Contract #: 04-0120F4  
 Cty: SF/ALA Rte: 80 PM: 13.2/13.9  
 File #: 69.25B

## QUALITY ASSURANCE -- NON-CONFORMANCE REPORT

**Report No:** NCR-000871

**Reference Description:** Excessive Root Gap on Fillet Welds

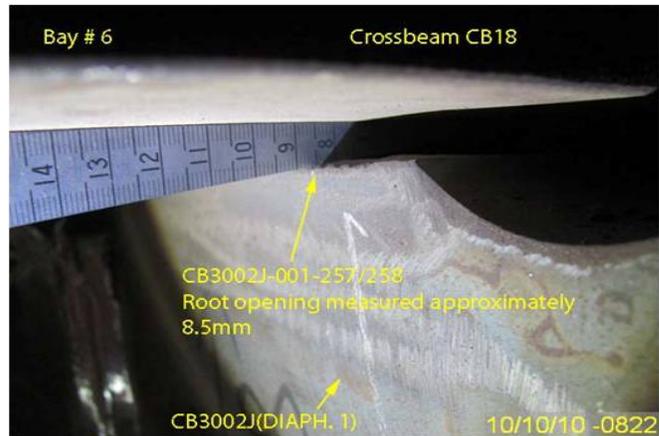
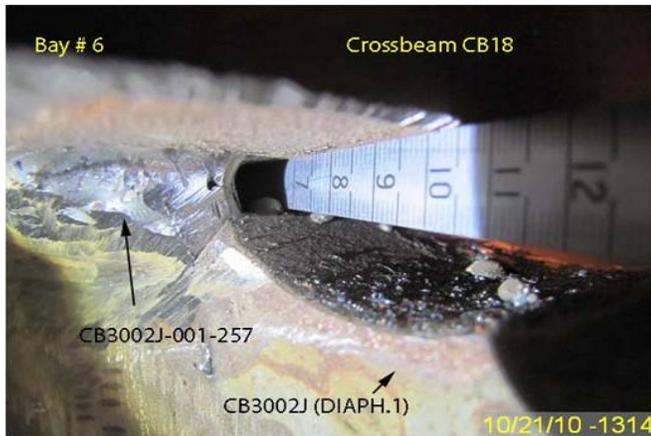
During the Caltrans Quality Assurance in-process observations of the fabrication of Crossbeam CB18, this Quality Assurance Inspector (QA) discovered the following issues:

- ZPMC personnel performed the Flux Cored Arc Welding process on fillet welds, which the root opening exceeded the maximum tolerance specified in the Welding Procedure Specification (WPS) and welding code.
- WPS # WPS-B-T-2134 and AWS D1.5 2002 specifies a root opening maximum of 5mm.
- The root openings on twenty six (26) welded joints were measured between 8.5mm and 10mm.
- The affected welds are identified as CB3002J-001- welds 253, 254, 257, 258, 261, 262, 075 and 076. CB3002J-002- welds 251, 252, 259, 260, 073 and 074. CB3002K-003- welds 251, 252, 255, 256, 167 and 168. CB3002K-004- Welds 251, 252, 255, 256, 073 and 074.
- These fillet welds join the Intermediate Web Panel-1 (CB3002E) Stiffener to the Longitudinal Diaphragm-1 Sub Assembly identified as CB3002J-001.
- This Crossbeam CB18 is located in Sub Assembly Bay #6.

Rectification was performed as the approved TC-RFI response. Partional fillets were changed to CJP where the root gap was over 5mm. The other locations were fixed with the installation of fit lags. ZPMC is providing the NDT record and revised weld maps for the CJPs and the fillet welds used to weld the fit lugs. Based on this, ZPMC is requesting closure of this NCR.

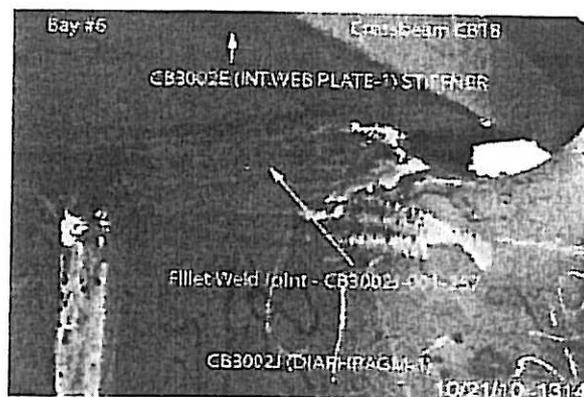
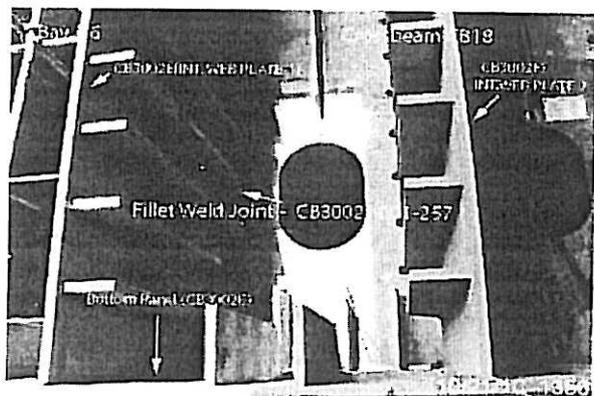
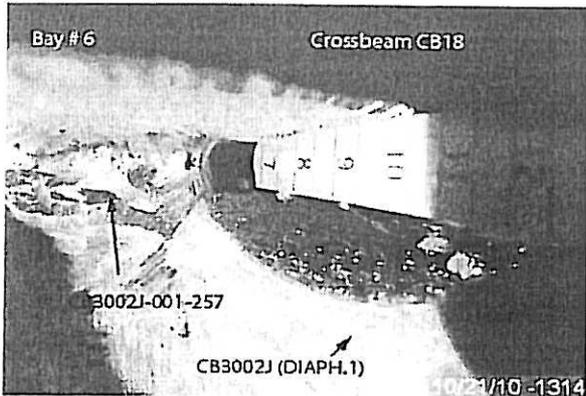
During the Caltrans Quality Assurance in-process observations of the fabrication of Crossbeam CB18, this Quality Assurance Inspector (QA) discovered the following issues:

- ZPMC personnel performed the Flux Cored Arc Welding process on fillet welds, which the root opening exceeded the maximum tolerance specified in the Welding Procedure Specification (WPS) and welding code.
- WPS # WPS-B-T-2134 and AWS D1.5 2002 specifies a root opening maximum of 5mm.
- The root openings on twenty six (26) welded joints were measured between 8.5mm and 10mm.
- The affected welds are identified as CB3002J-001- welds 253, 254, 257, 258, 261, 262, 075 and 076.
- CB3002J-002- welds 251, 252, 259, 260, 073 and 074. CB3002K-003- welds 251, 252, 255, 256, 167 and 168.
- CB3002K-004- Welds 251, 252, 255, 256, 073 and 074.
- These fillet welds join the Intermediate Web Panel-1 (CB3002E) Stiffener to the Longitudinal Diaphragm-1 Sub Assembly identified as CB3002J-001.
- This Crossbeam CB18 is located in Sub Assembly Bay #6.

Contractor proposes to change the fillet weld to CJP. NDT will be performed after welding. Contractor will provide a revised weld map, and NDT report to prove the weld is acceptable.

Contractor repaired the welds, and NDT was performed. The NDT weld result is acceptable. The revised weld map have been submitted.

DATE: 2010/12/22  
DRAWING NO: CB3002J

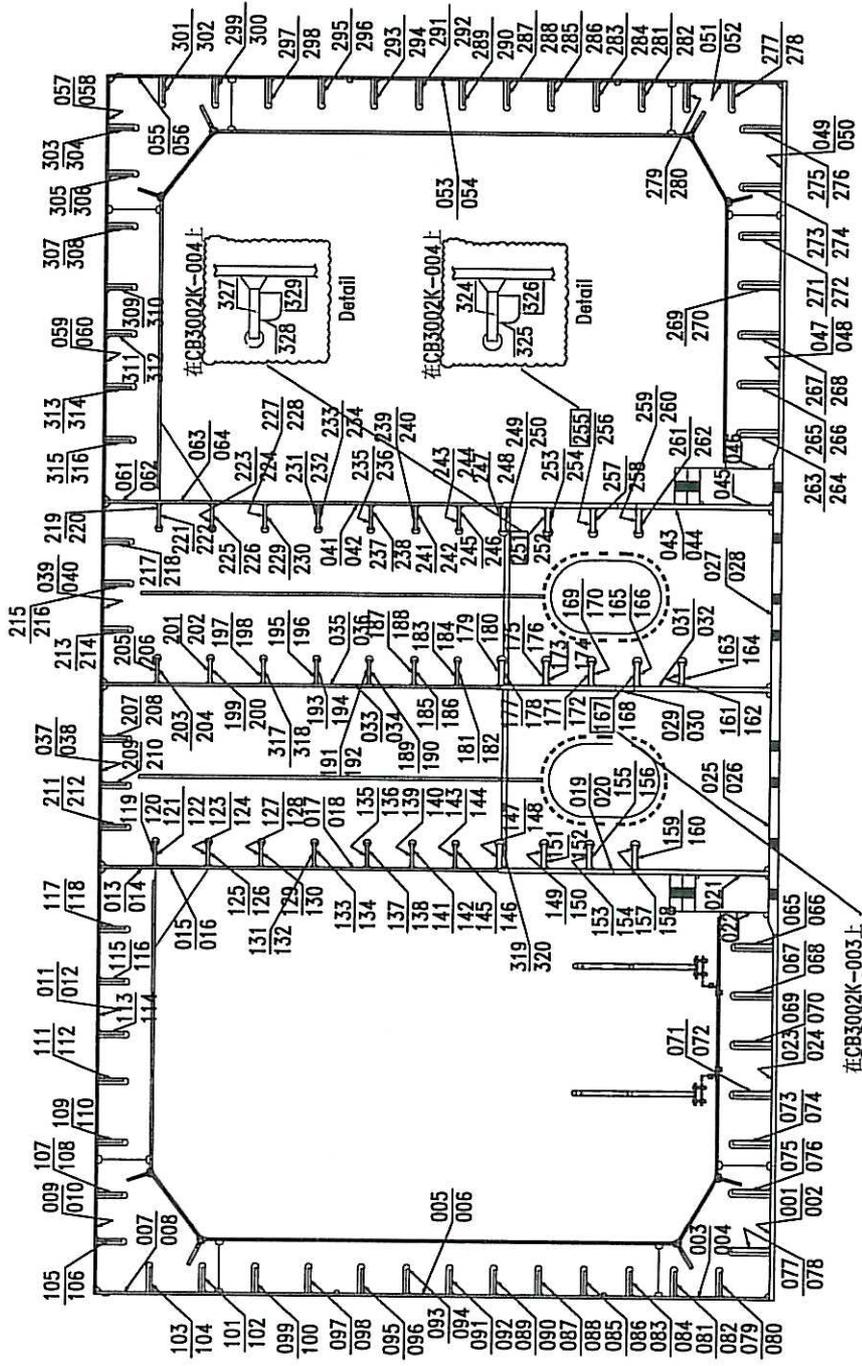
1.原角焊缝,253/254,257/258,261/262,077/078,075/076在CB3002J-001由CJP焊缝号253,257,261,077,075替换;  
 2.原角焊缝251/252,259/260,077/078,075/076,073/074在CB3002J-002由CJP焊缝号251,259,077,075,073替换;

3.原角焊缝,107/108,151/152,155/156,207/208,209/210,211/212,在CB3002J-001由CJP焊缝号107,151,155,207,209,211替换;  
 4.原角焊缝303/304,305/306,207/208,209/210,211/212在CB3002J-002由CJP焊缝号303,305,207,209,211替换;

5.原角焊缝,257/258,261/262在CB3002J-001增加补板后由CJP焊缝号320,321,322,323,324,325替换;(补板见详图)  
 6.原角焊缝251/252,259/260在CB3002J-002增加补板后由CJP焊缝号329,330,331,326,327,328替换;(补板见详图)
